MICHIGAN DEPARTMENT OF ENVIRONMENTAL QUALITY

SUBJECT: Review of "Report on Water Level Testing Under Reduced Flow Conditions
Pall Life Sciences – Evergreen Area"

Figure 1 – Groundwater level recovery versus distance from LB-1.

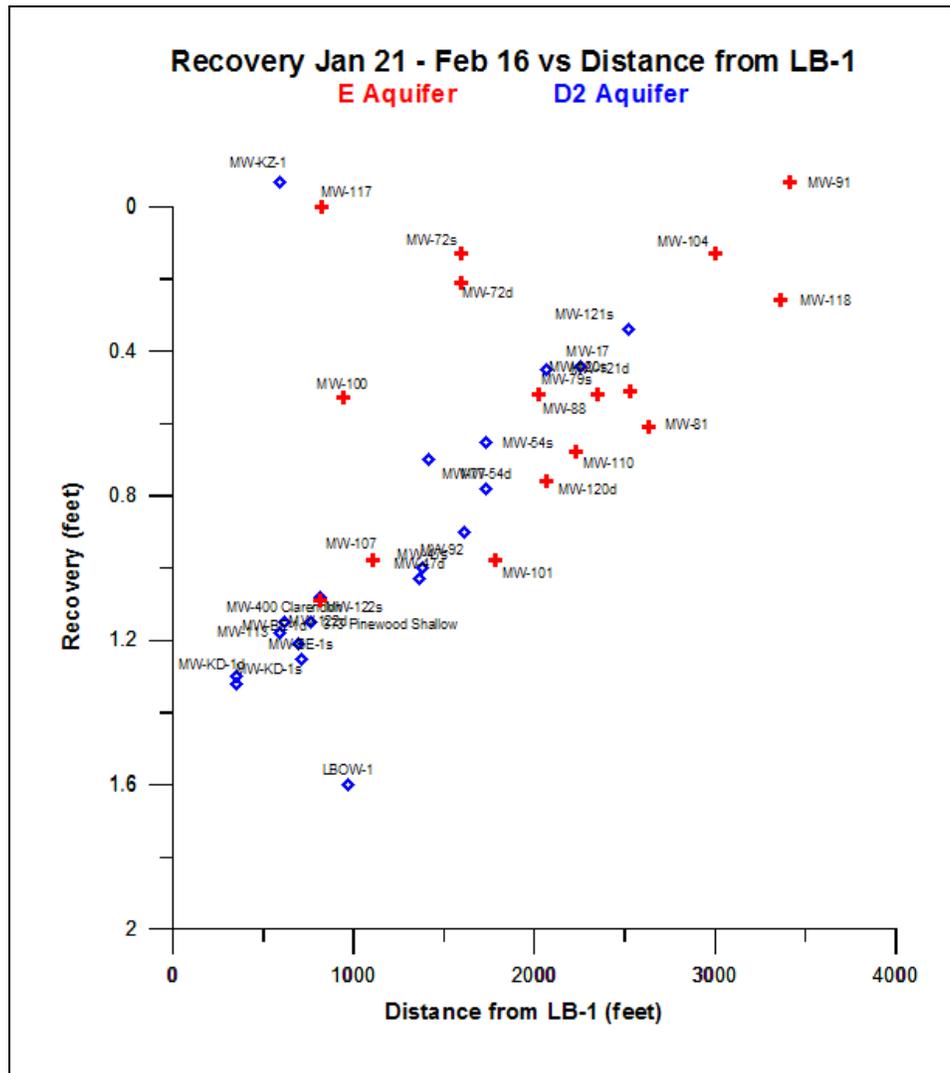
Measured groundwater level recovery (January 21 through February 16, 2009) that occurred as a result of terminating pumping from the Evergreen Area wells was plotted versus distance from the LB-series (see Figure 1). The purpose was to determine whether all wells measured during this investigation were screened in the same aquifer. In a laterally continuous aquifer, wells closest to the pumping wells will show the greatest water level recovery and those farthest from the pumping well will show the least amount of recovery. Wells that are not screened in the same aquifer and without a hydraulic connection will not show a response to the reduction or termination of the pumping. The recovery data plotted in Figure 1 show that almost every well responded as if the aquifer in which it is screened is part of a laterally continuous aquifer. The exceptions were wells MW-KZ1, MW-117, MW-100 and MW-72s&d. The remaining wells that responded in a manner consistent with a single laterally continuous aquifer had previously been designated as being screened in either the D2 or E aquifer; however, because of the similar manner in which they responded as a group, this demonstrates that they are actually screened in the same aquifer, some at different depths. The fact that the wells do not all plot along a line is an indication that there is horizontal and vertical heterogeneity in the aquifer.

There was no observable response in wells MW-KZ1 and MW-117 as noted by PLS. These wells are screened in intervals that are not connected to the contaminated aquifer from which the Evergreen Area wells pump. The MDEQ has long held this position and has tried to prevent these wells from being used to depict groundwater flow directions or the extent of 1,4-Dioxane concentrations. Data from these two wells should not be included in any future maps showing the groundwater flow directions or extent of contamination in this area.

Also, the level of recovery at MW-100 and MW-72s & d is less than would be expected if these wells were screened in an aquifer that had good hydraulic connection to the aquifer in the

Evergreen Area. The presence of clay and silt rich sediment located between these wells and the Evergreen Area may be the reason for the lower rate of response.

There was measurable groundwater level recovery in wells MW-120s and MW-120d between January 21 and February 16 in a manner that is consistent with other wells that are located at a similar distance from the LB-series wells (MW-88, MW-79s, MW-110, MW-54s&d), indicating that both MW-120s and MW-120d are hydraulically connected to the same aquifer from which the Evergreen Area wells extract groundwater. We have no technical reason for dismissing the data from MW-120s&d; however, we would not make a decision regarding pumping rates in the Evergreen Area without confirming the flow pattern inferred on Figures 4, 6, and 8, or without further monitoring to the north-northeast.
